RE: REVISED DRAINAGE PLAN FOR PARADISE VISTA SUBDIVISION (B11-D2A)
REVISION DATED 10/16/97

PROJECT TITLE: Paradise Vista Subdivision

RE: Paradise Vista Subdivision (B11-D2A) Grading and Drainage Plan

STREET CAPACITY

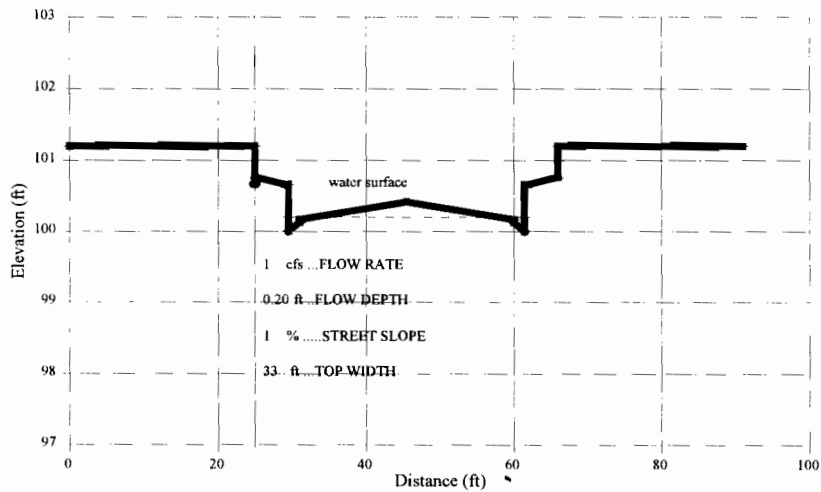
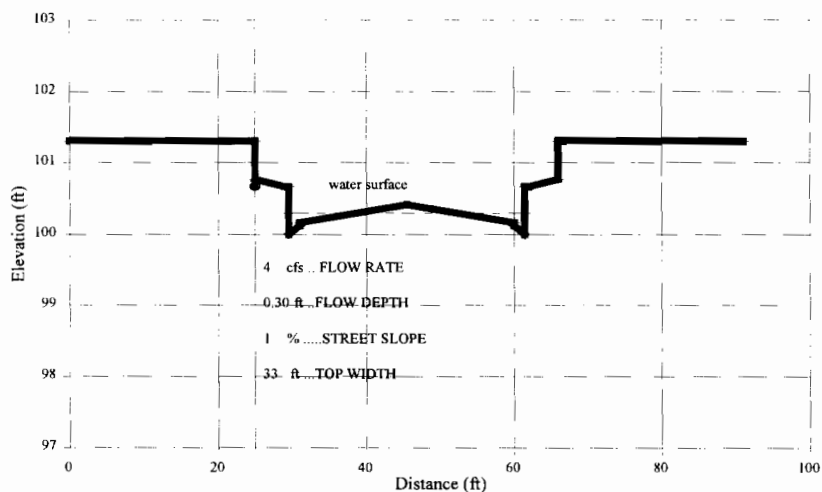
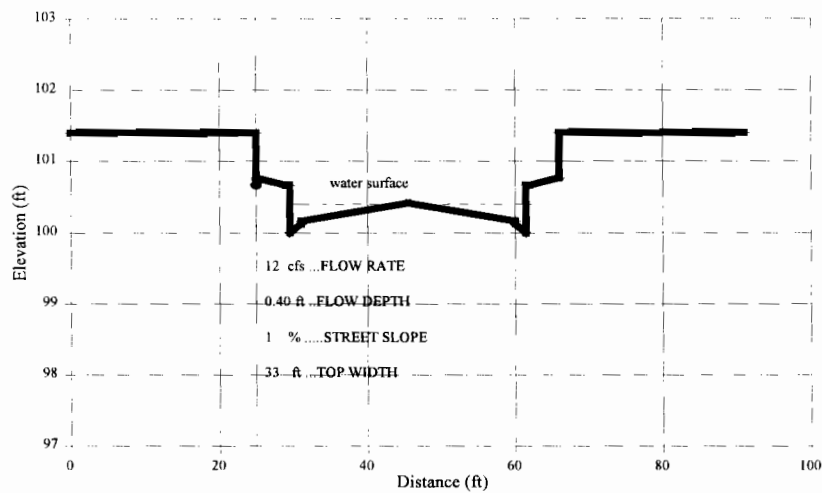
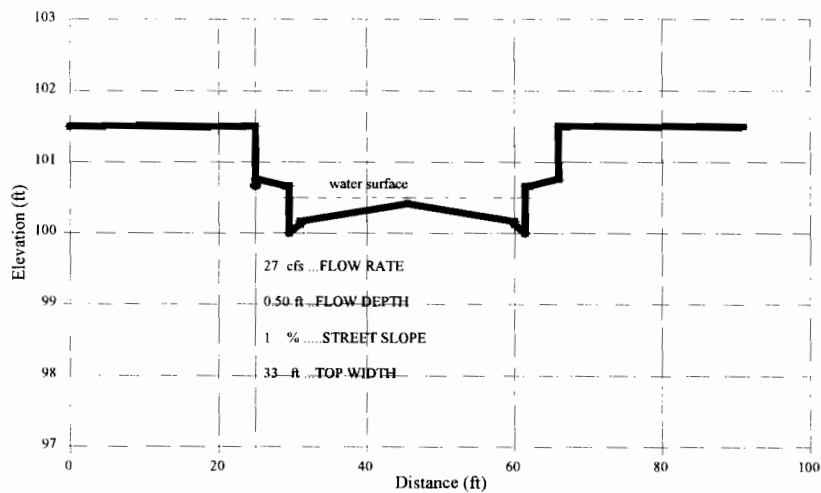
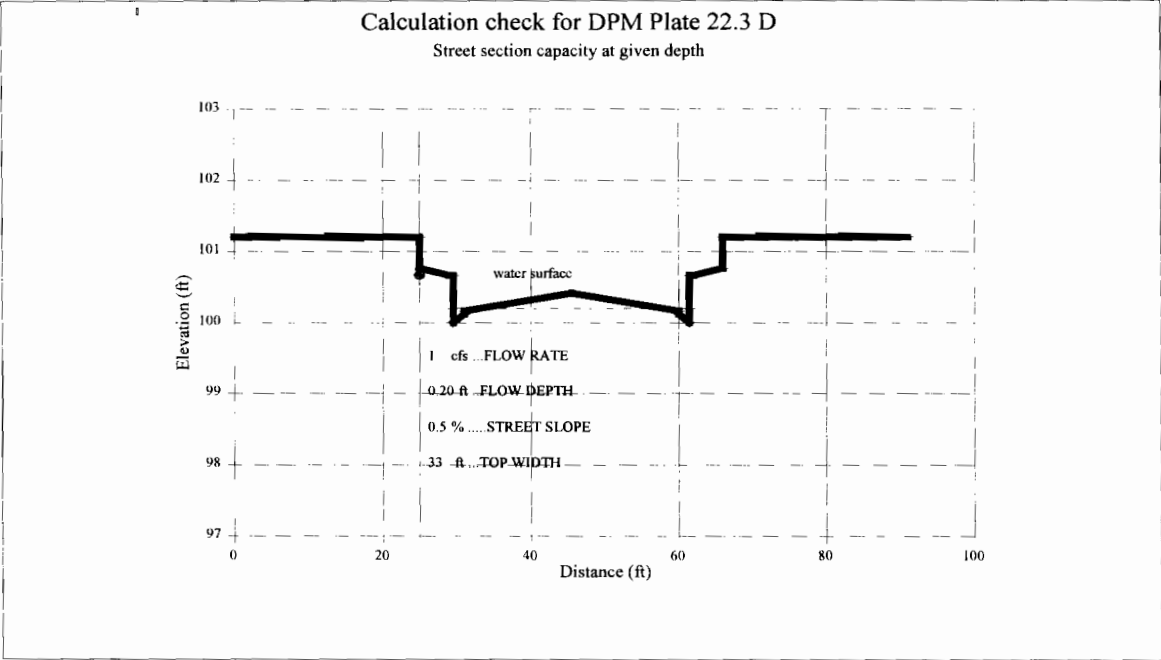
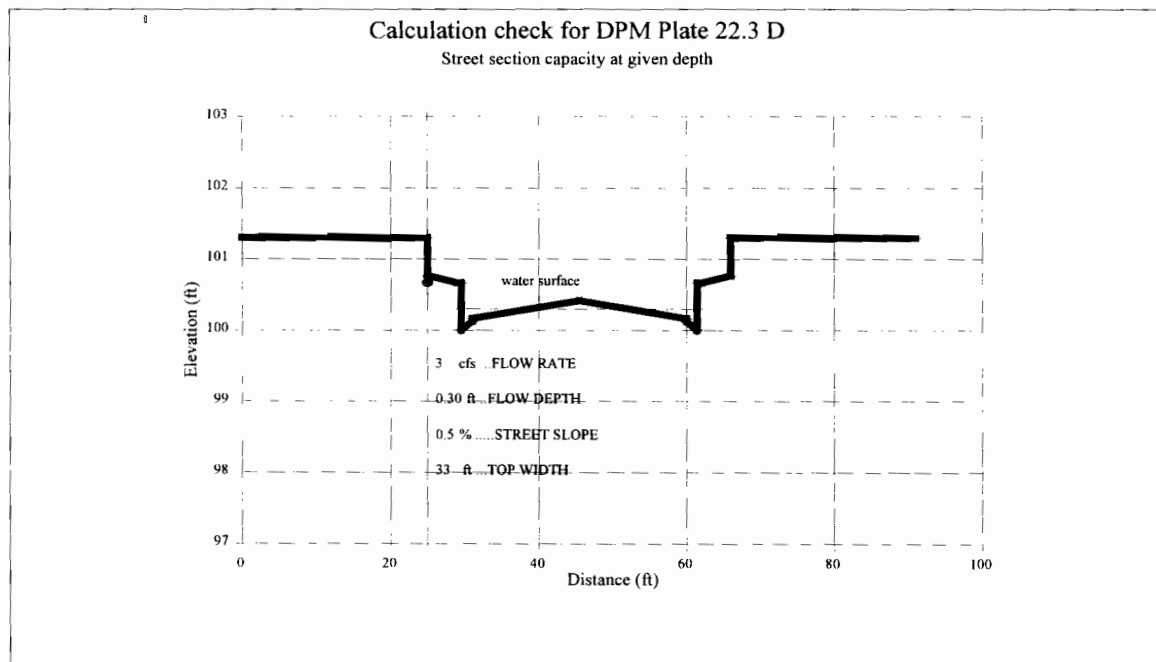
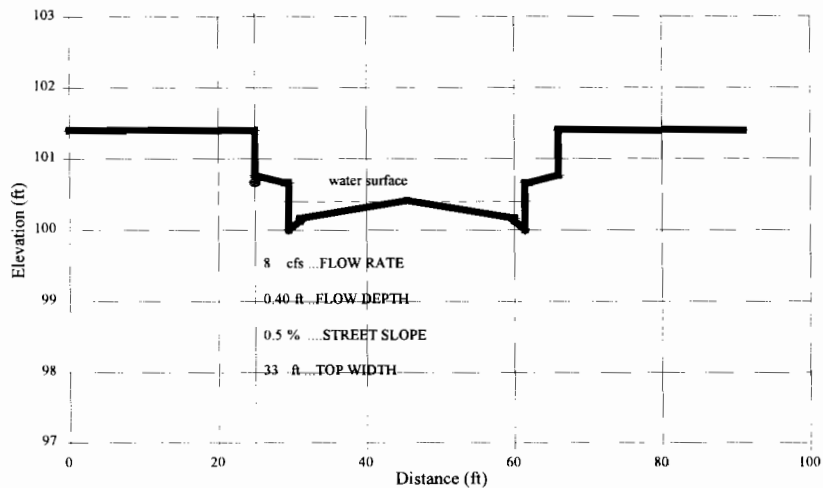
- ok 1. The street capacity analysis with my spreadsheet template "Hydrapak" is more detailed and versatile than the DPM street capacity graphs. The template will calculate open channel flow capacity for streets with normal crown; inverted crown; streets with medians; with sidewalks or without; and variable curb and gutter dimensions. The DPM street section analyzes only a triangle flow area for a half street. Attached are some examples of the spreadsheet printout with the corresponding DPM graph. The DPM graph consistently shows a slightly higher street capacity than the spreadsheet. Calculations and graph attached.
